Niagara Mohawk

RE: Nine Mile Point Unit 2
Docket No. 50-410
NPF-69

Subject: *Submittal of Revision 13 to the Nine Mile Point Nuclear Station Unit 2 Updated Safety Analysis Report and the 10 C.F.R. §50.59 Safety Evaluation Summary Report (TAC No. MB0304)*

FIGURE 1.2-1

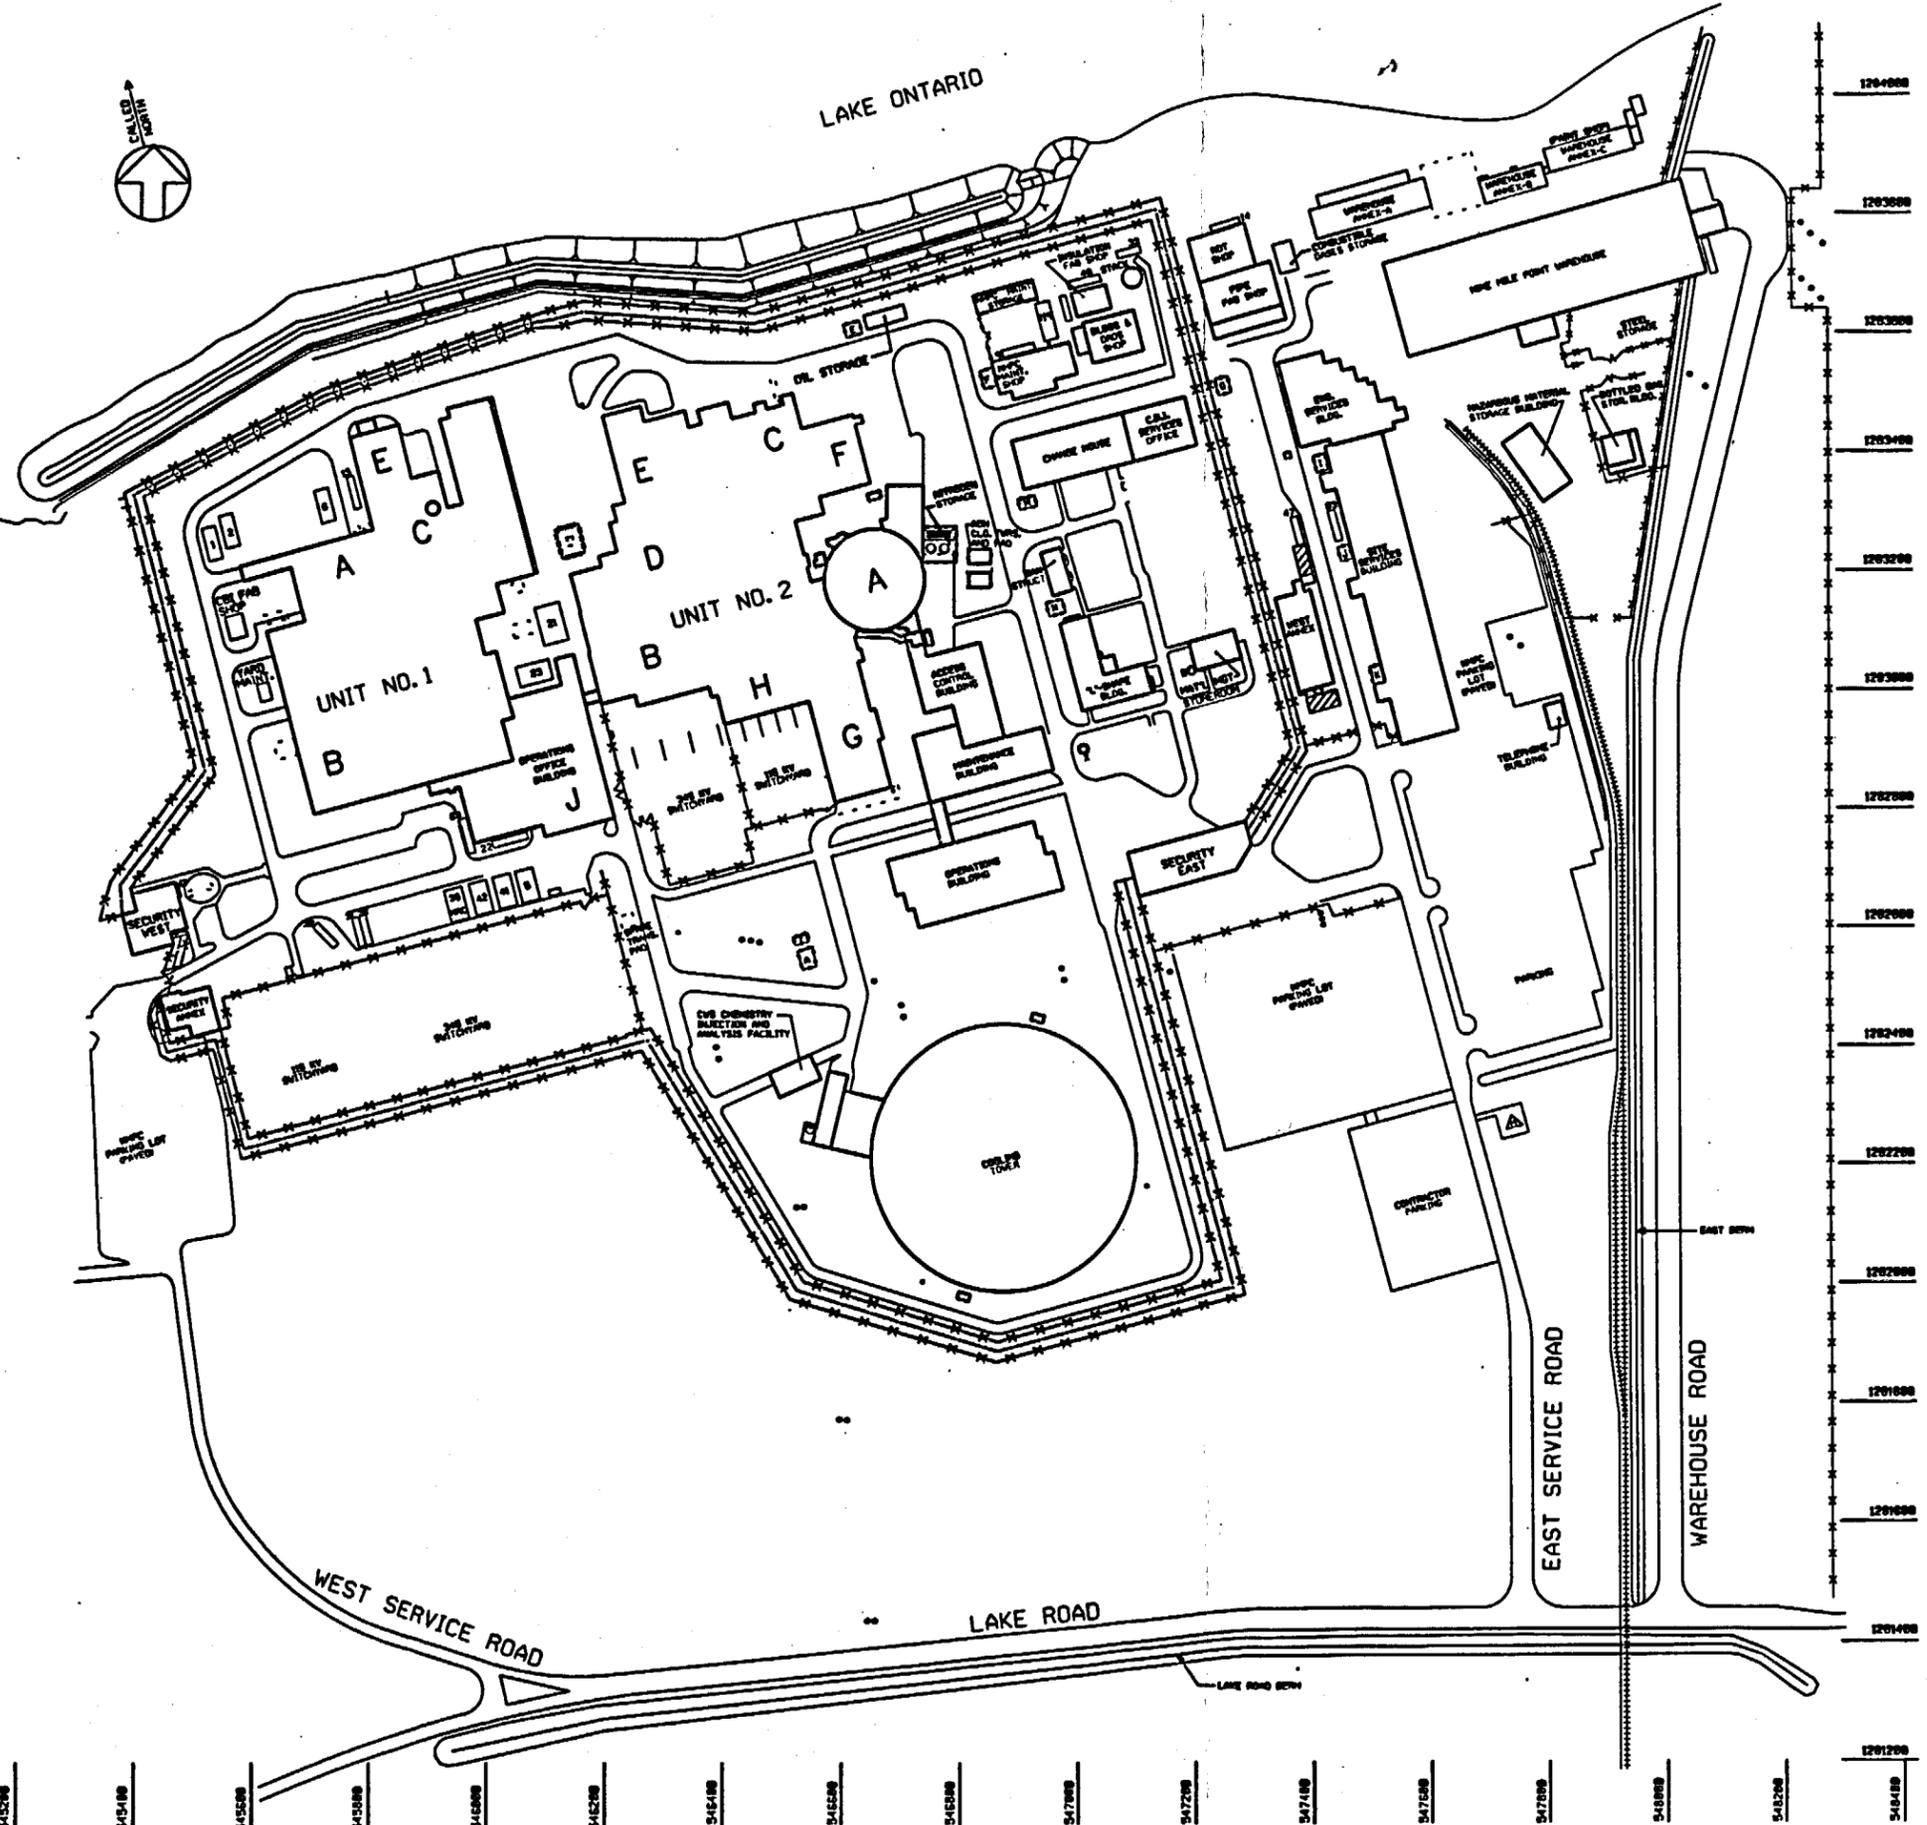
Safety Evaluation No.: 98-019
Implementation Document No.: DDC 2S11106
USAR Affected Pages: Figure 1.2-1
System: N/A
Title of Change: Demolition of Steel Fab Shop

FIGURE 1.2-10

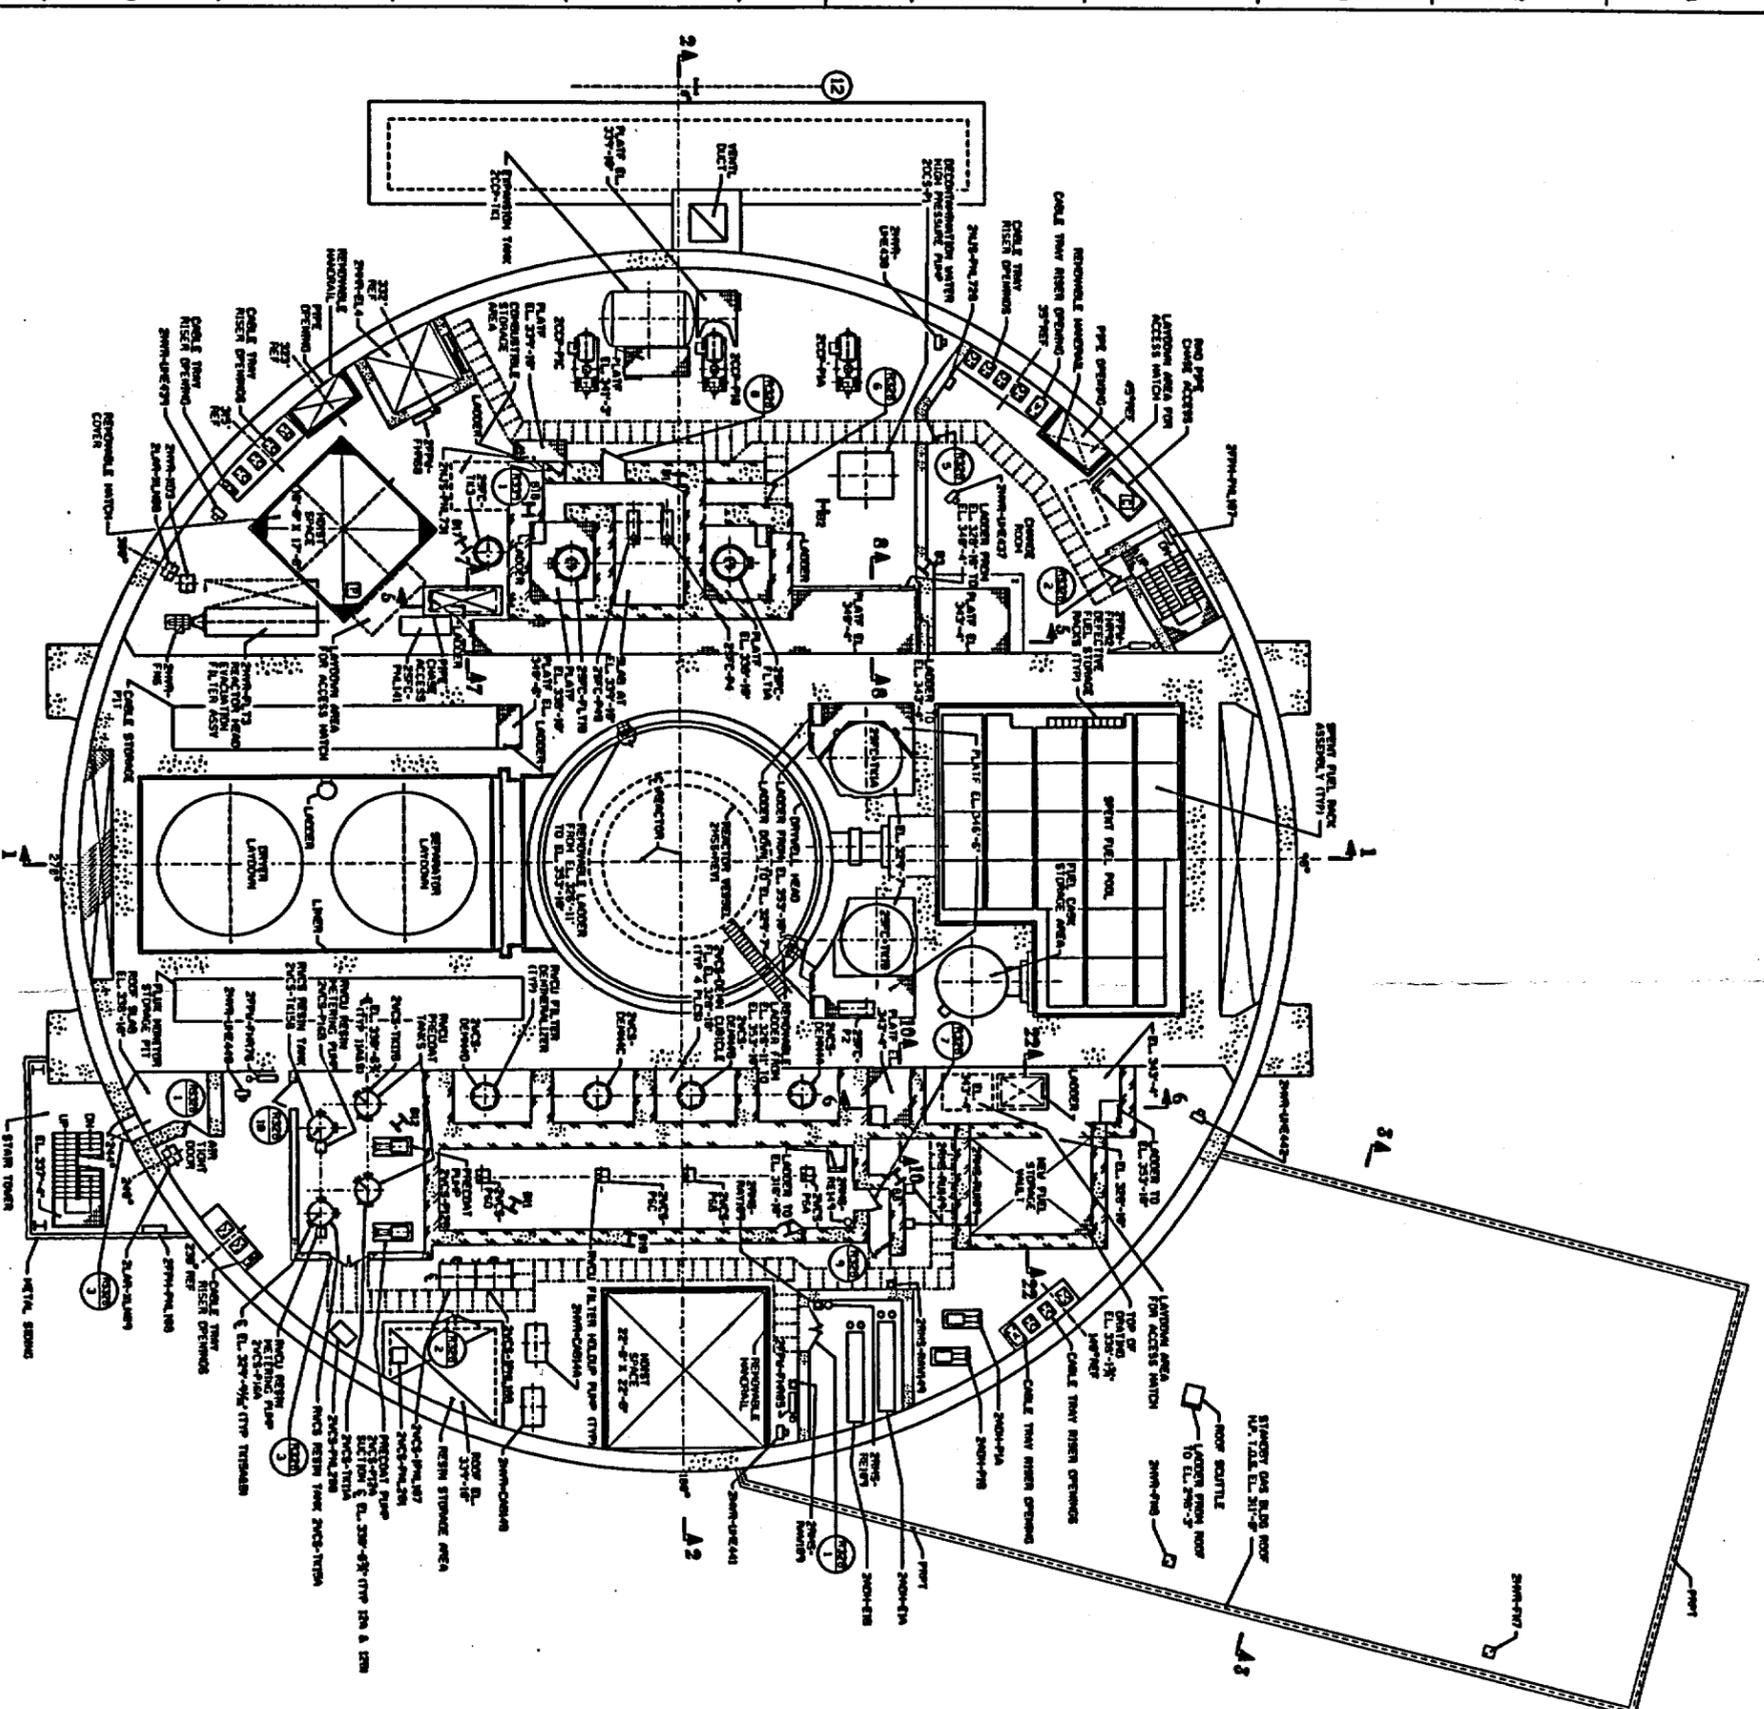
USAR Affected Pages: Tables 9A.3-1 Sh 9, 9B.5-1; Figure 1.2-10 Sh 1

SOURCE: EE-278
 FIGURE 1.2-15
 GENERAL ARRANGEMENT
 CONTROL BUILDING
 RELAY & COMPUTER ROOMS EL.288'-6"
 SHEET 2 OF 4

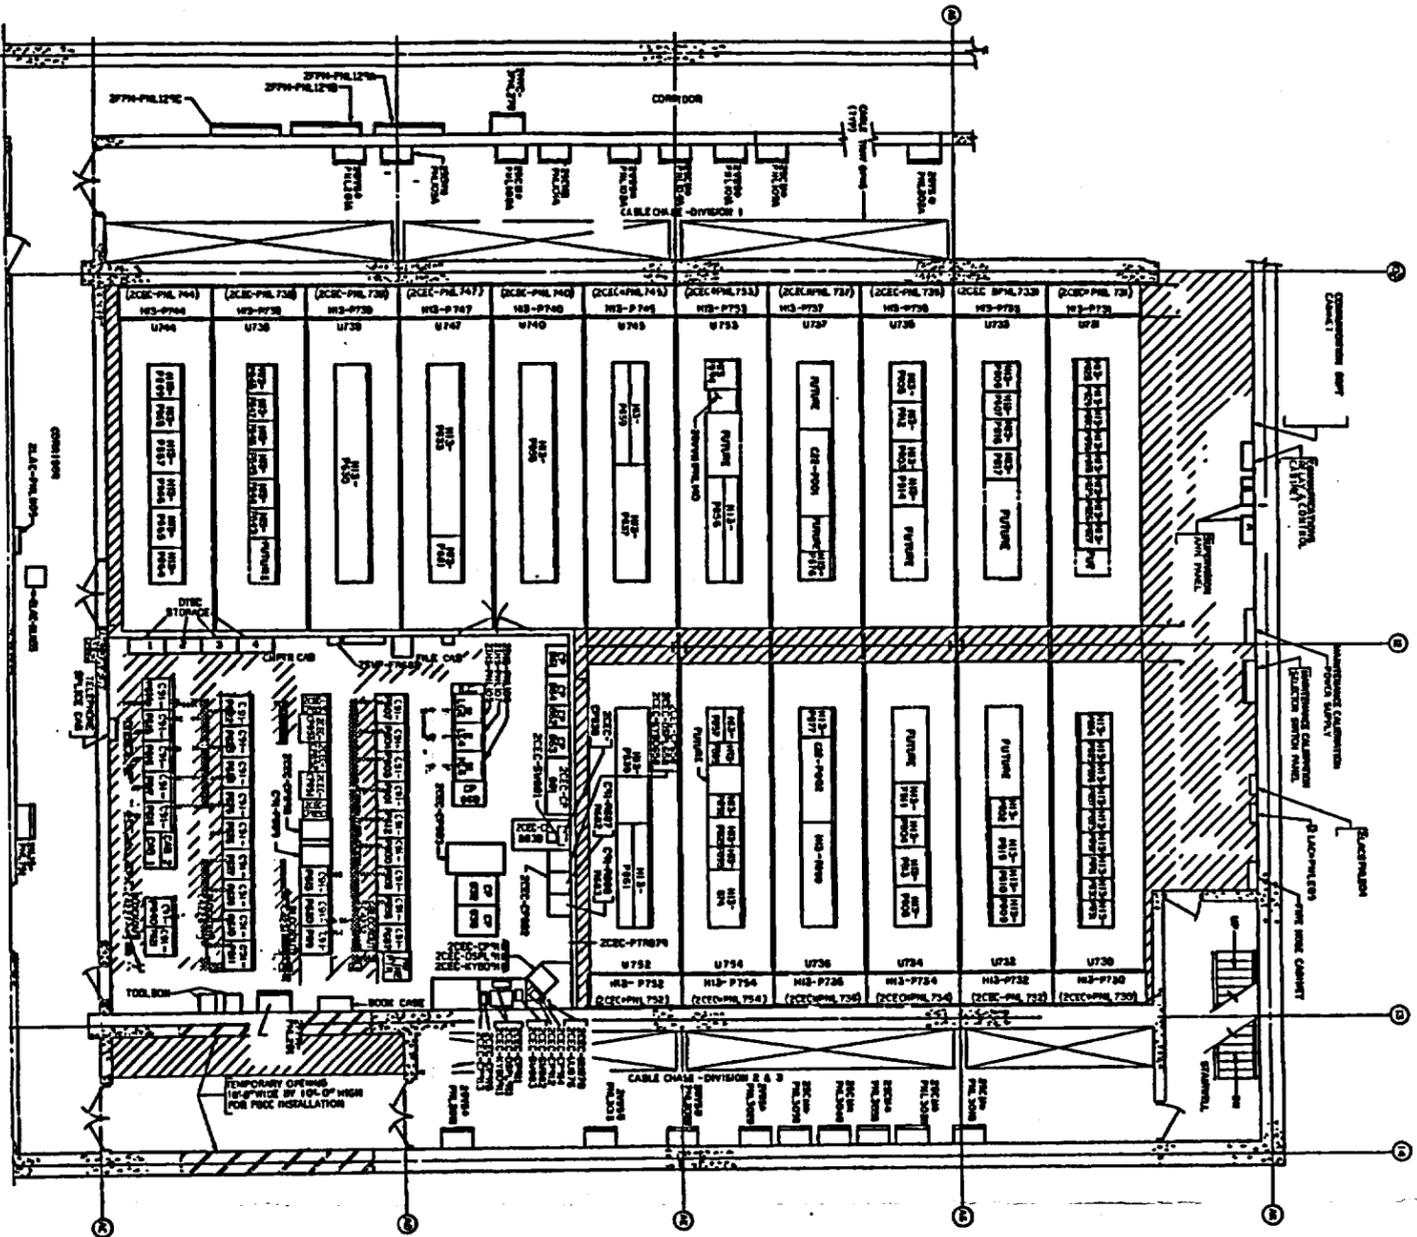
USAR Affected Pages: 7.7-33; Figure 1.2-15 Sh 2
